EXTRAORDINARY COUNCIL MEETING

ITEM 4.1 SUBMISSION TO DEPARTMENT OF PLANNING, HOUSING AND INFRASTRUCTURE - HOMEBUSH TRANSPORT ORIENTED DEVELOPMENT (TOD) REZONING SUBMISSION

- Attachments:
1. DRAFT Submission - Homebush TOD - City of Canada Bay Council [↓](#)
 2. Explanation of Intended Effect - Homebush TOD Rezoning Proposal
 3. Design Guide
 4. Urban Design Report
 5. Independent Traffic Review - Bitzios
-

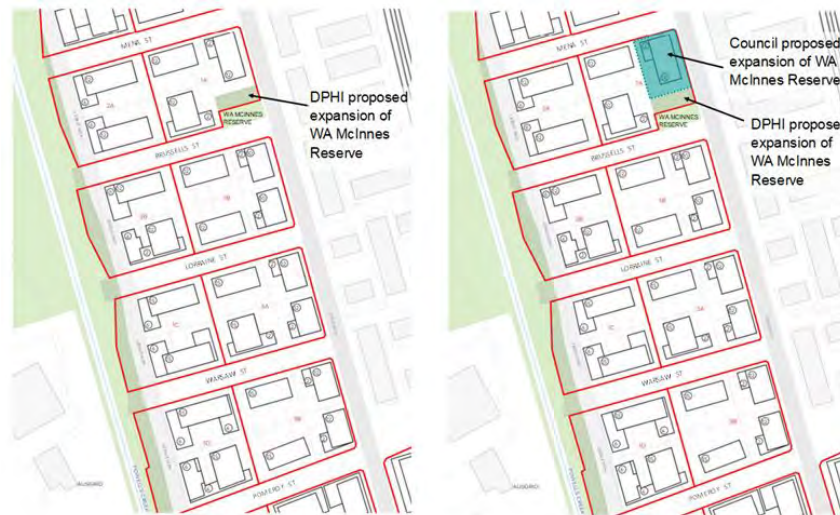
However, if one or both schools are relocated, the new Park should be planned for the centre of the site, at the end of Malta Avenue. Despite the location of Hamilton Street bridge, any plaza located further north would create more direct access for pedestrians and cyclists approaching the site from the north, west and south. The Hamilton Street shared zone would then move to Malta Avenue.

It is recommended that the proposed open space and associated main access to North Strathfield Station be located further north to better service the entrances of the metro and train station.

Brussels St and Mena St sky view comparison.

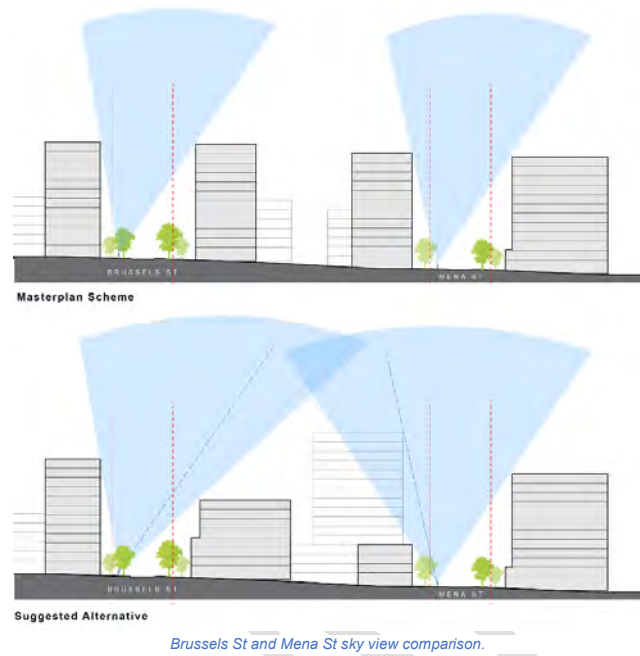
GFA (m ²)	Public open space	Flood storage space	Buildings in flood zone	Street wall height
Masterplan scheme	37,209	1,121	1,813	2	2-12 storey
Alternative scheme	34,591	1,530	2,978	0	4 storey
Change	7% decrease	136% increase	64% increase	reduction	reduction

Figure 5: Access and Movement network

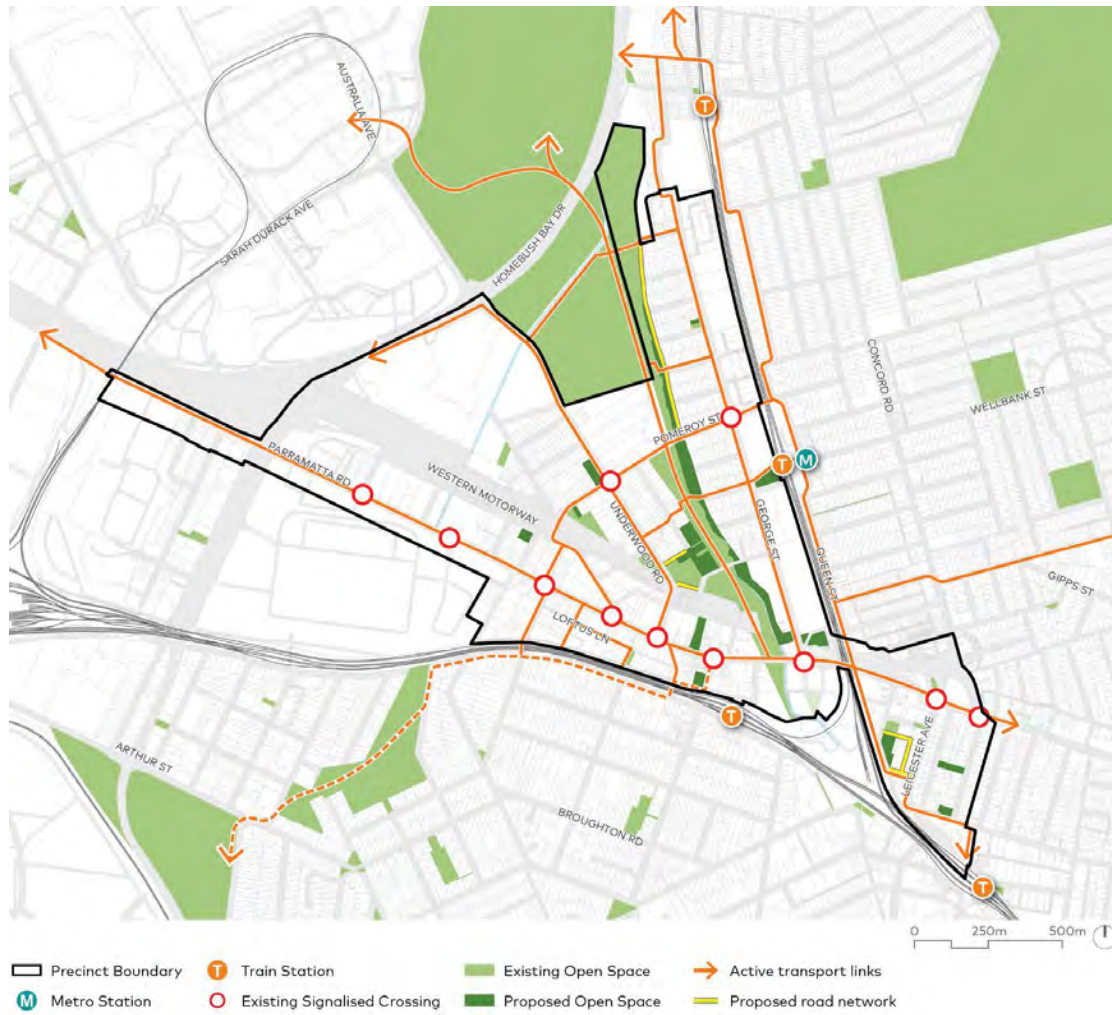
- Figure 5 Access and Movement Network should show active transport links in more detail to better guide future development. Existing and planned footpaths, separated cycleways, shared paths, on-road cycleways should all be shown differently on the plan to avoid confusion.

Figure 10: Street wall and podium heights

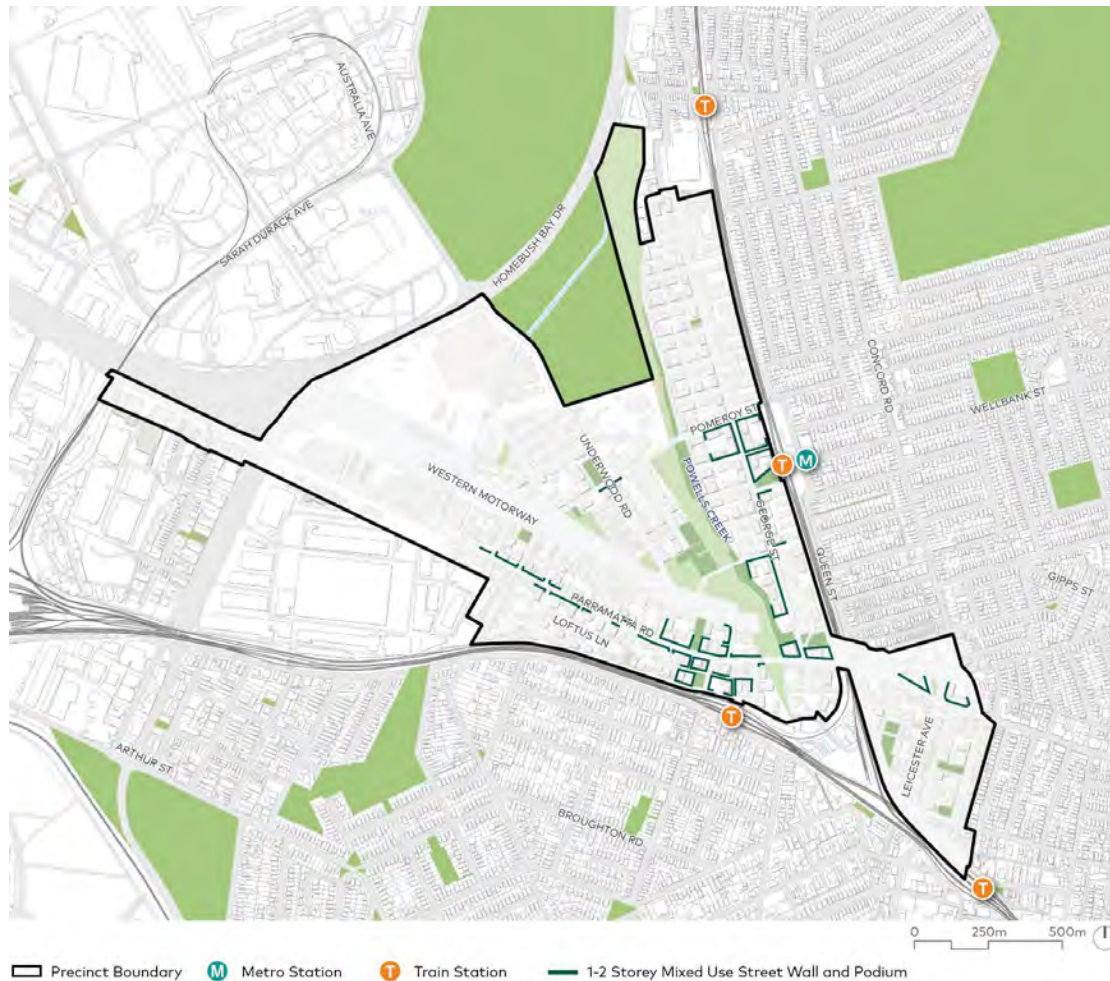
- Figure 10: A 1-2 storey podium is shown for 165 Parramatta Rd. Suggest this is raised to 3-4 storeys and that residential uses are not permitted within the podium facing highway infrastructure. This is to ensure that the lowest level of future residences have reasonable visual privacy and are able to open their windows.

Figure 25: Existing Natural Considerations

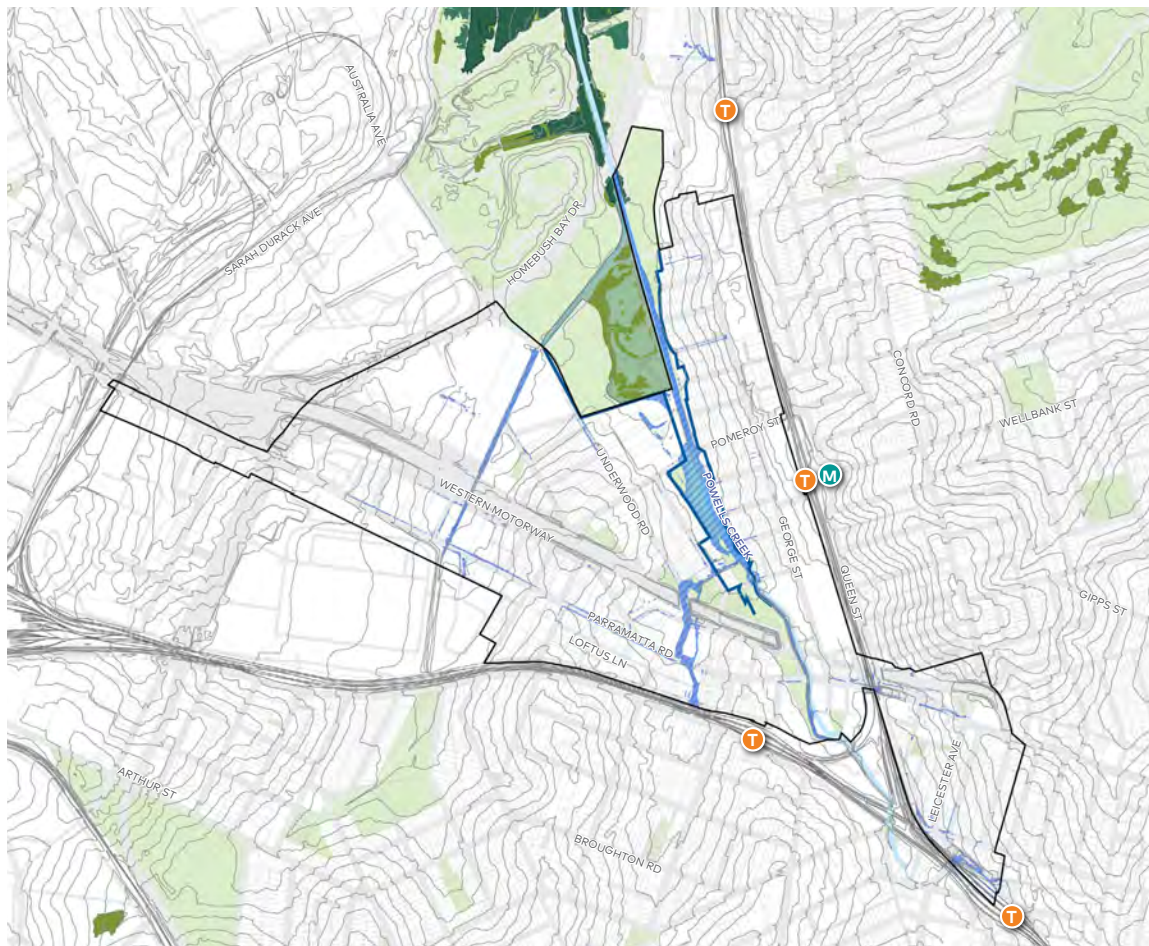
The *Urban Design Report*, which includes a Flood Division Line (Figure 25) references the Flood Assessment as the source of the data. However, the Flood Assessment does not reference or map the Flood Division Line. It is therefore unclear how it has been determined and there is no nexus between the two studies, providing no confidence that the Flood Division Line has been drawn in the correct location.
